ESV Validation Report

United Energy 2018-2019
Fire Start Report

Final report

Figure 1: Differences in the fire start location for incident 20190304UTD_03

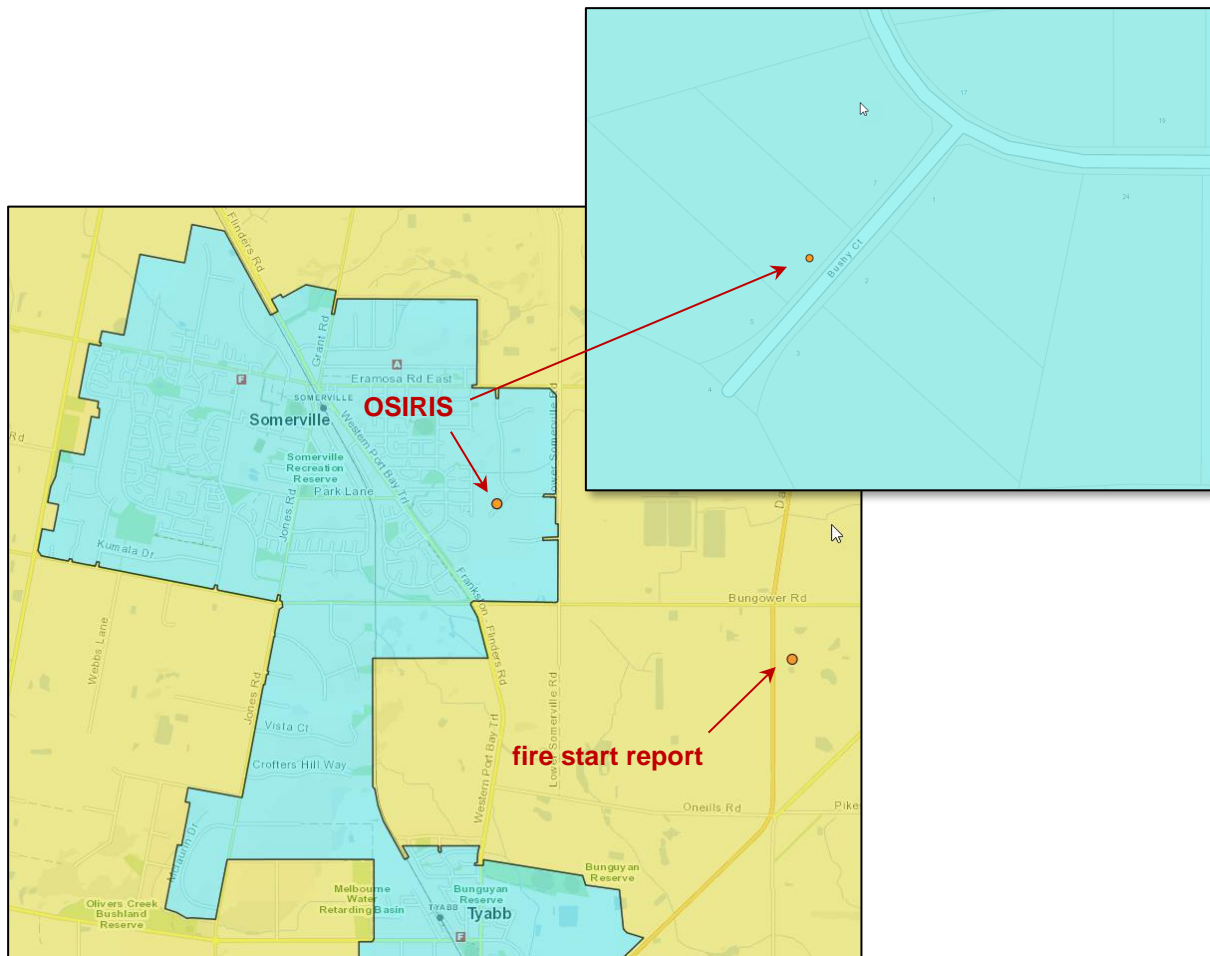
- Incident 20190304UTD_03

ESV has referred this incident back to United Energy on multiple occasions. In reviewing this incident, United Energy has focused on the transposition of coordinates with another incident but has not reviewed the corrected coordinates of this incident. This needs to be further reviewed as the location in the fire start report is about 2.5 km from the location in OSIRIS. It is worth noting that the OSIRIS location is in agreement with the address provided for the incident. Figure 1 shows the location of the incident according to OSIRIS and the fire start report.

If the OSIRIS location is correct, the effect would be to reduce the IRU calculated for this incident and the total IRU amount.

OSIRIS report	Amend OSIRIS	Amend fire start report	ESV and United Energy commentary
20190304UTD_02 20190304UTD_03	No	Yes	<p>The two locations are over 40 km apart.</p> <p>ESV's assessment was that the coordinates provided for incidents 20190304UTD_02 and 20190304UTD_03 have been transposed.</p> <p>The incident times also differs between OSIRIS and the fire start report, and also appear to have been transposed.</p> <p>United Energy corrected the latitude, longitude and incident time in the Rev.2 fire start report.</p>
20181002UTD_03 20181019UTD_02	No	Yes	<p>The two locations are about 10-15 km apart.</p> <p>ESV's assessment was that the coordinates provided for incidents 20181002UTD_03 and 20181019UTD_02 have been transposed.</p> <p>The incident times also differs between OSIRIS and the fire start report, and also appear to have been transposed.</p> <p>United Energy corrected the latitude, longitude and incident time in the Rev.2 fire start report.</p>
